Access Compliance Report

Public Rights-of-Way

(Curb Ramps)

Intersection ID: 11741	Main Street: COUNTRY CLUB DR	Cross Street: MATHESON AV	Location:	E
ADA ID: 3FB75ED33F1F	Ramp Type: Perp	Initial Pass/Fail: Fail	Overall Compliance: No	Severity Score: 10
Codes/Mitigation Info/Possible Solution		Field Measurements/Component Compliance

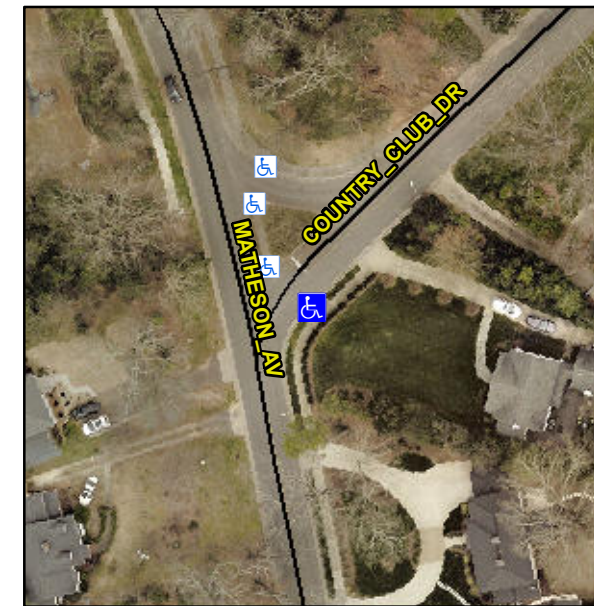
Not Found, R304.5.1, R304.5.3

Compliance	Description	Data	Compliance	Description	Data
N/A	Ramp Length (in)	50.0	Yes	Ramp Slope (%)	5.2
No	Ramp Width (in)	44.0	No	Ramp XSlope (%)	3.1
N/A	Flare Type LT	N/A	N/A	Flare Type RT	N/A
N/A	Flare Slope LT (%)	N/A	N/A	Flare Slope RT (%)	N/A
N/A	Flare Traversable LT?	N/A	N/A	Flare Traversable RT?	N/A
N/A	Landing Length (in)	N/A	N/A	DWS Provided?	N/A
N/A	Landing Width (in)	N/A	N/A	DWS Contrast?	N/A
N/A	Landing Slope (%)	N/A	N/A	DWS Length (in)	N/A
N/A	Landing X Slope (%)	N/A	N/A	DWS Full Width?	N/A
N/A	Landing Curb? (Y/N)	N/A	N/A	DWS Offset (in)	N/A
N/A	Shared Landing?	N/A			
N/A	Gutter Ponding?	N/A	N/A	Gutter Slope (%)	N/A
N/A	Gutter Lip Ht (in)	N/A	N/A	Gutter X Slope (%)	N/A
N/A	Painted X Walk1?	No	N/A	Painted X Walk2?	N/A
	X Walk 1 Direction	To N		X Walk 2 Direction	N/A
N/A	X Walk 1 Width (in)	N/A	N/A	X Walk 2 Width (in)	N/A
	X Walk 1 Slope (%)	3.0		X Walk 2 Slope (%)	N/A
	X Walk 1 X Slope (%)	4.5		X Walk 2 X Slope (%)	N/A

Remove & Replace Entire Ramp.
